Falcon Highlands South Filing No. 1

Final Drainage Report

SF2418

April 2, 2025
June 2, 2025
July 25, 2025
September 03, 2025
March 21, 2026

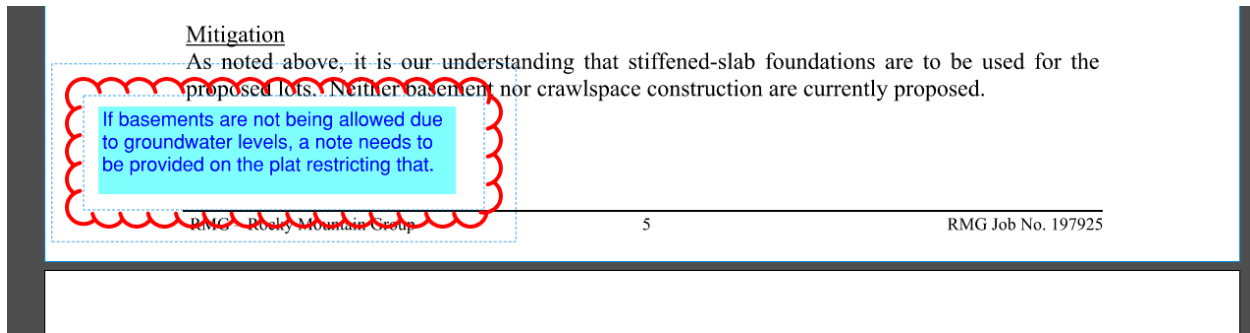
Comment below states there is at least 14 ft between ground and water elevation. Based on table, that is not the case, and this TB is right in the middle of the proposed site. Piezometer shows water levels way less than 14 ft as well.

Incorrect. The statement that the clouded comment is referring to is a reiteration (in our *Addendum* report) of a statement that was made in our original *Soils and Geology Study*. Our original report indicated that basement construction should be restricted except where one of three conditions were met, and listed what those conditions are. That restriction and its associated conditions were duplicated in the *Addendum* letter to provide context for the groundwater discussion. They were not included as an evaluation of (nor were they intended to indicate) whether or not any of those three conditions were met.

Profile Report
Engineering Profile - STORM RUN 1 (24004308-StormCAD-2024-12-11.stsw)
Active Scenario: 5-year

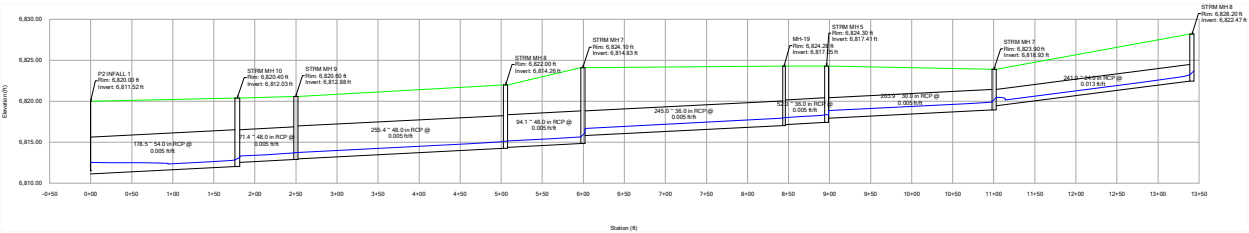
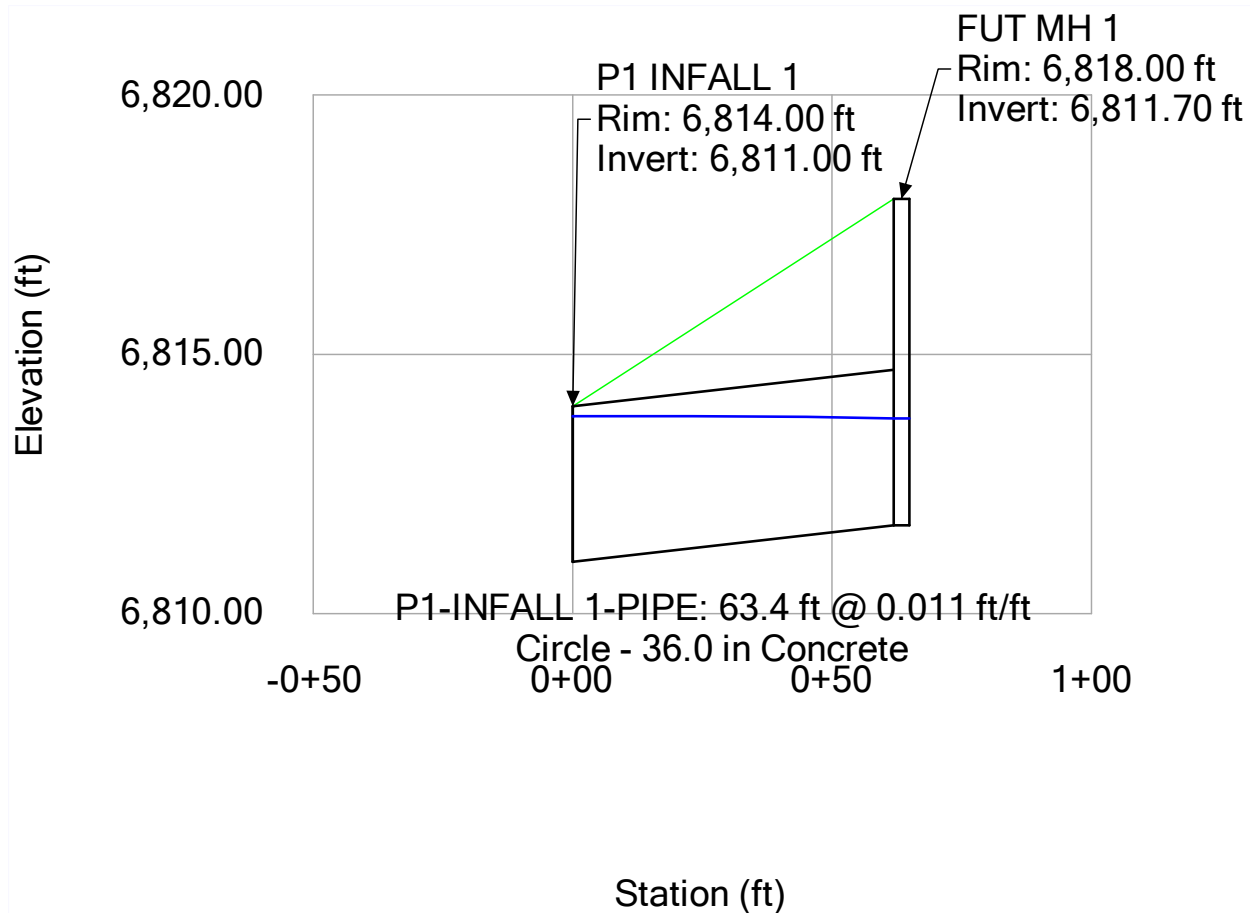
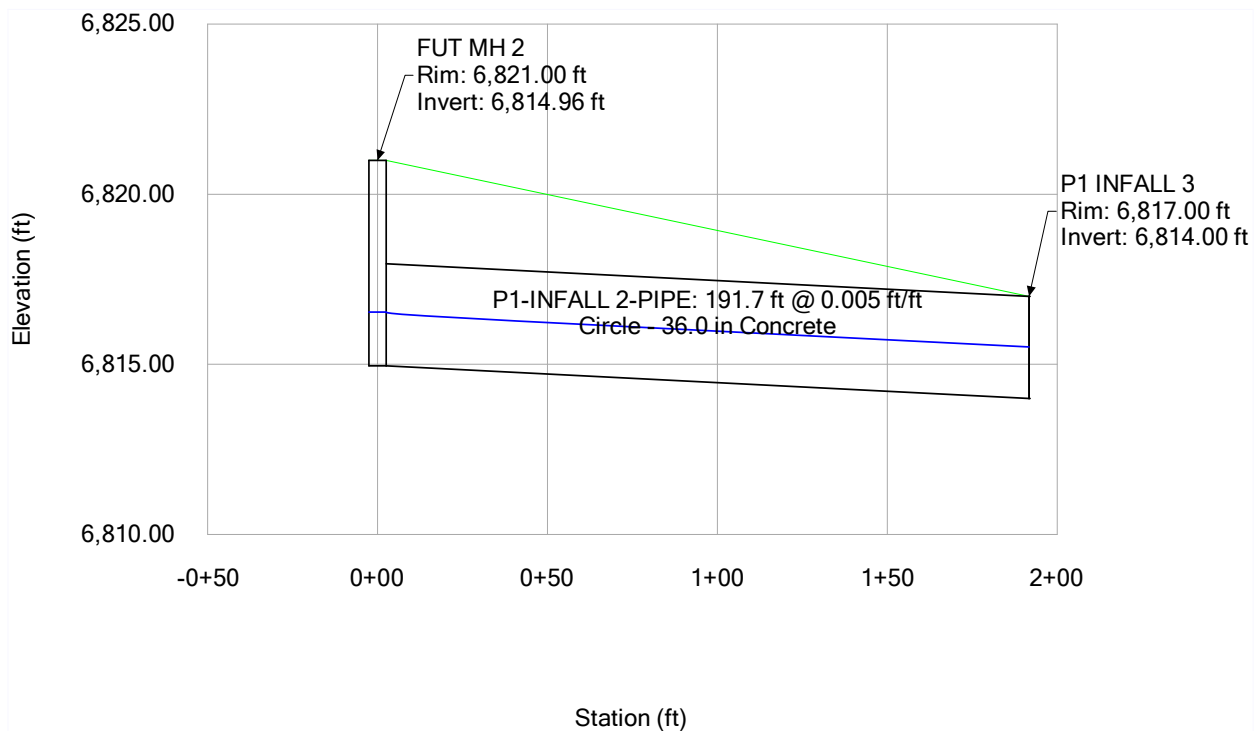
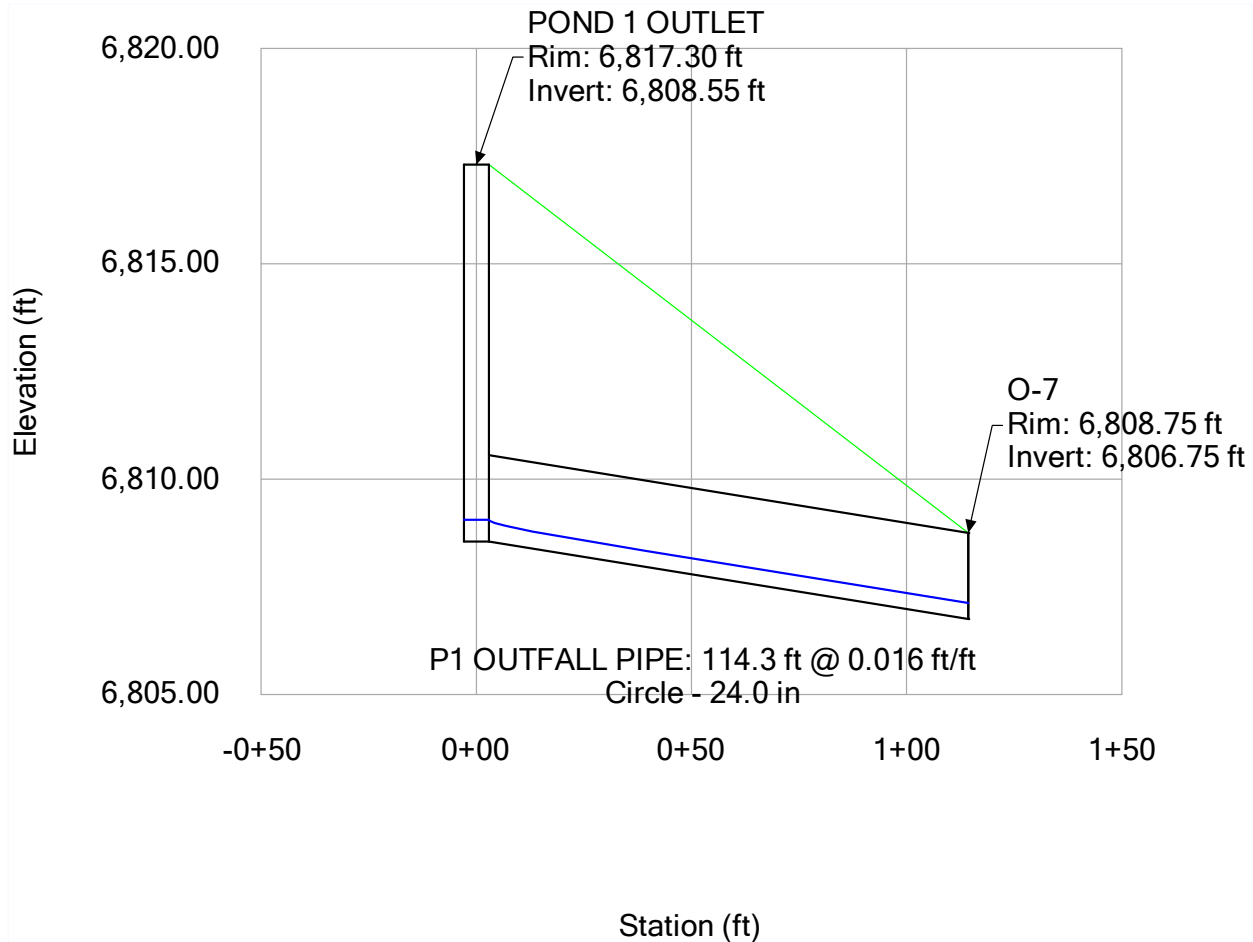
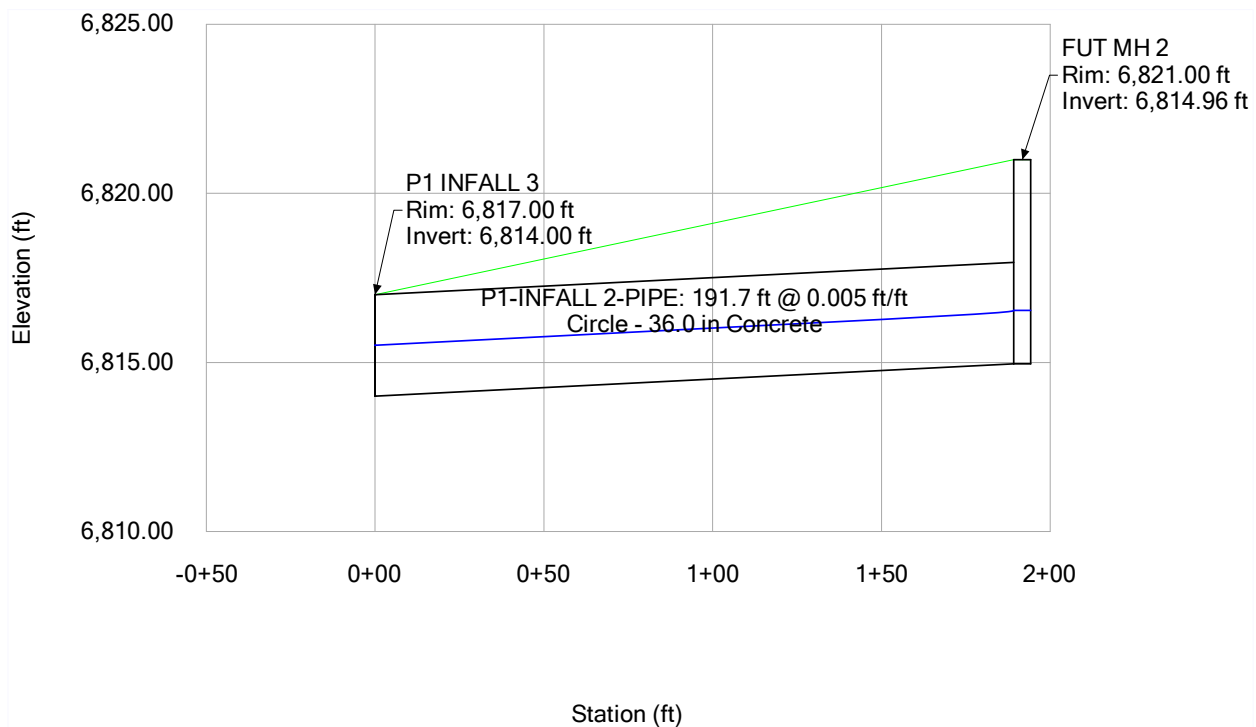
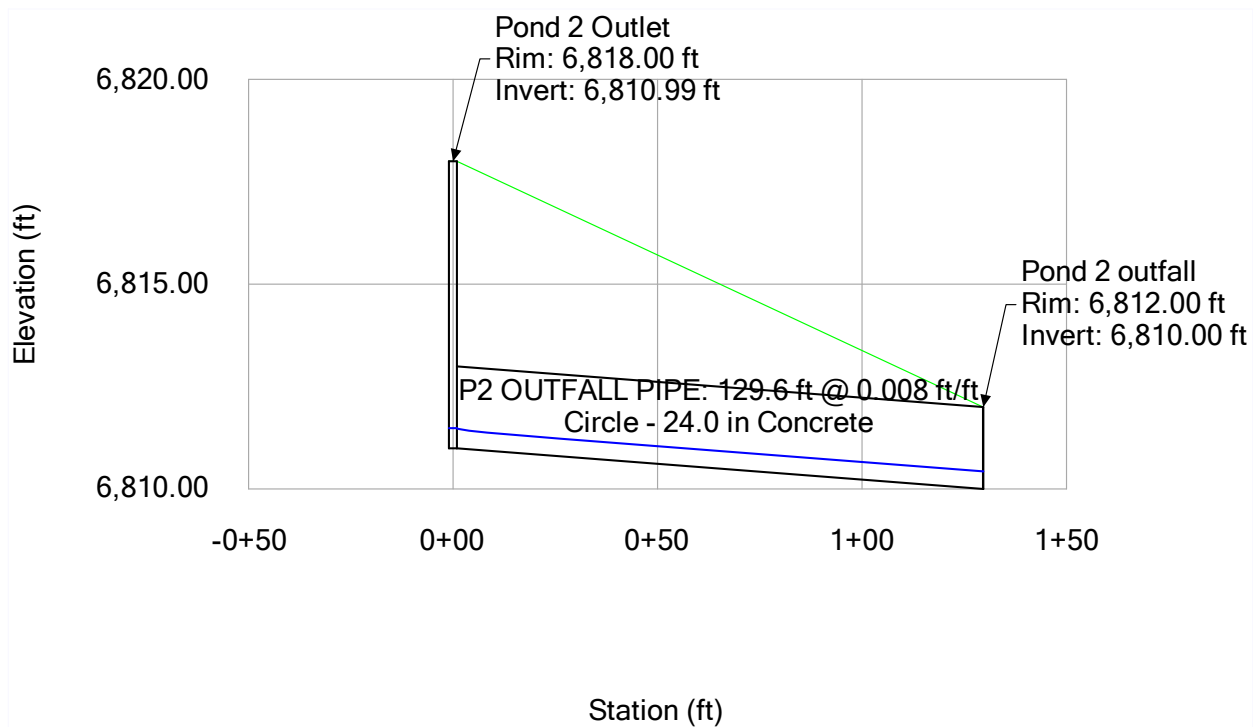
Unresolved:
Inconsistencies between stormcad design and CDs. See CD's for highlighted information that does not match. Please check entire system for accuracy.
It would be helpful if naming convention was consistent between stormcad and CDs.
